**GARVEY COMMONS/  
 SHERBURNE HALL  
 ADDITIONS & REMODELING**  
 ST. CLOUD STATE UNIVERSITY  
 ST. CLOUD MINNESOTA

**33 GARVEY COMMONS BASEMENT FLOOR PLAN**  
 EXISTING FINISH FLOOR ELEVATION - 1025'-5"  
 1/8" = 1'-0"

**FLOOR PLAN - GARVEY COMMONS**  
 EXIST. FINISH FLOOR ELEVATION = 1037.37" = 1037'-4 1/2"  
 NEW FINISH FLOOR ELEVATION = 1037.12" = 1037'-5"

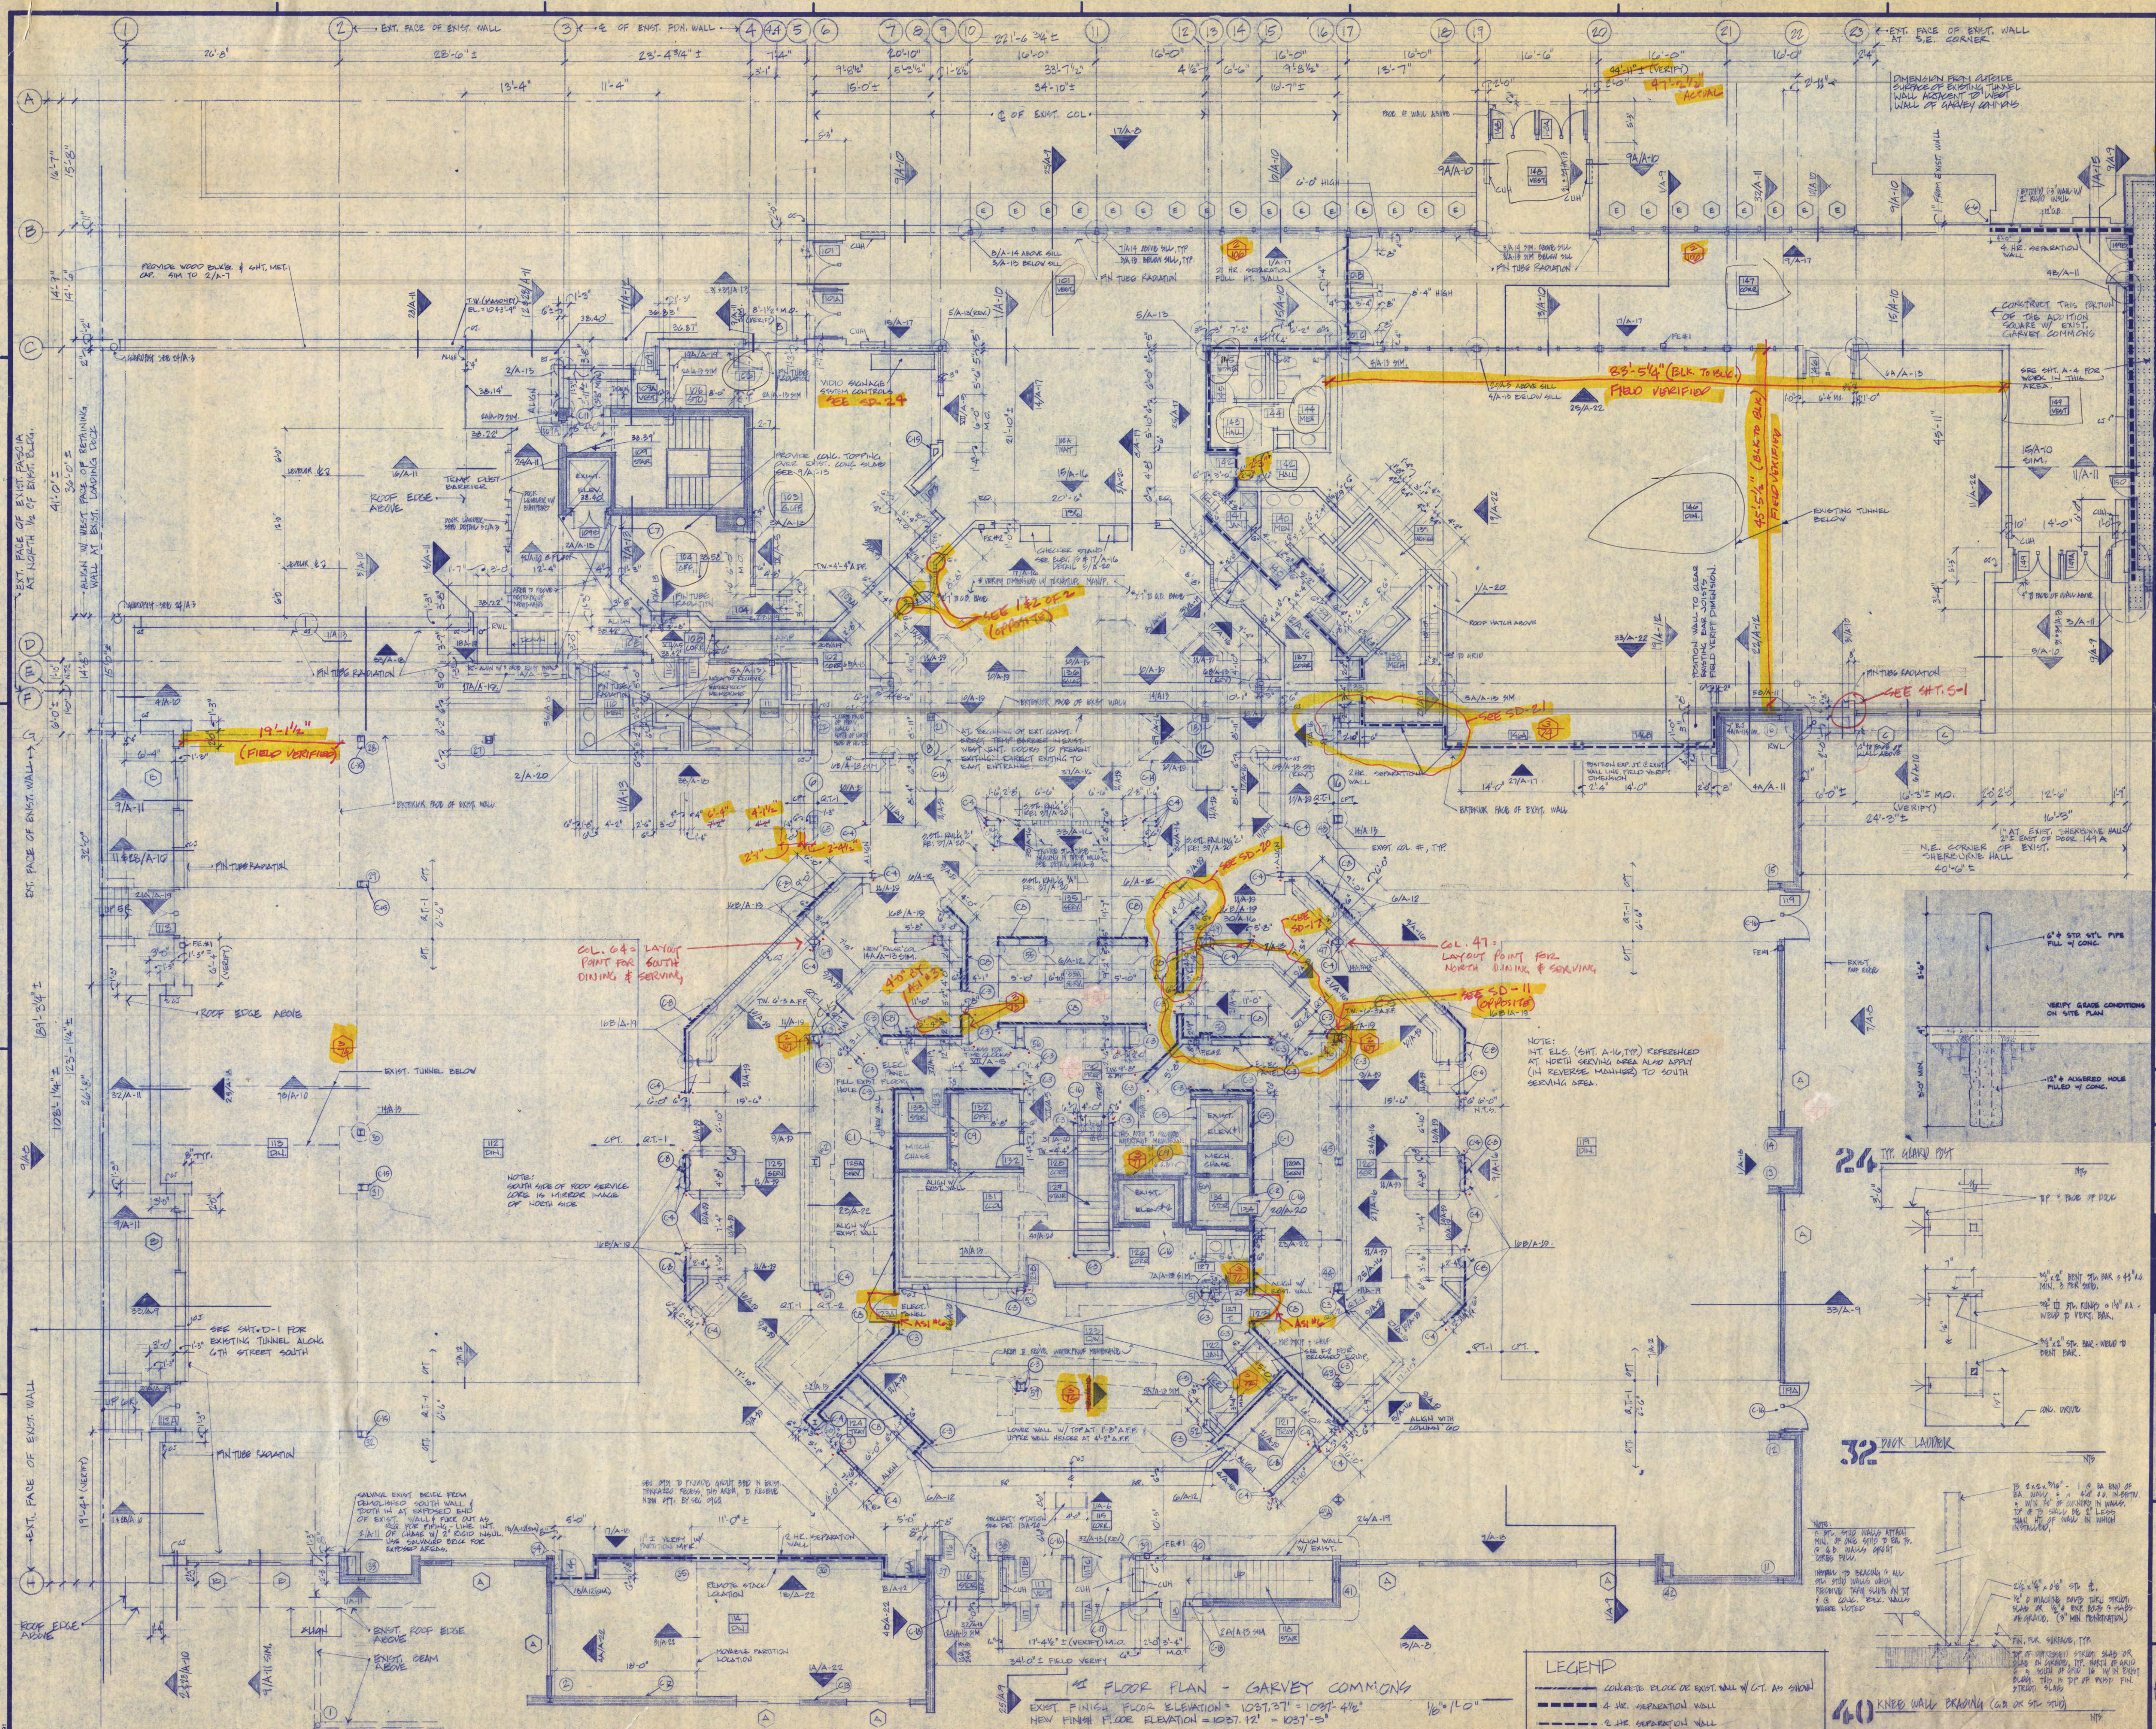
- 103. The Owner will repair the ceiling in the dishroom after removal of the dishmachine by the Contractor.
- 104. Change Existing Elevator #2, to Existing Elevator #1.

- 105. Provide additional temporary dust barriers:
  - a. At the south side of Existing Elevator #1.
  - b. At the bottom of wide, center stair to first floor.

- Provide dust tight doors as required for access in temporary dust barriers.
- 67. Door 806 shall have the swing reversed so that it swings out of Room 806. Hinges shall remain on the east jamb.

- 68. Revise Construction Note C-1 to read: Remove existing elevator hoistway south shaft wall (including existing door and frames), pit south foundation wall, and a portion of the pit slab. See Sheet SD-2, issued with the Addendum, for additional information.

- 68A. The General Contractor shall remove, and subsequently re-install, the existing door and frame located immediately north of existing elevator #1 to facilitate delivery of food service equipment item #103, by the FSEC. All existing adjacent finishes shall be patched to match existing conditions.
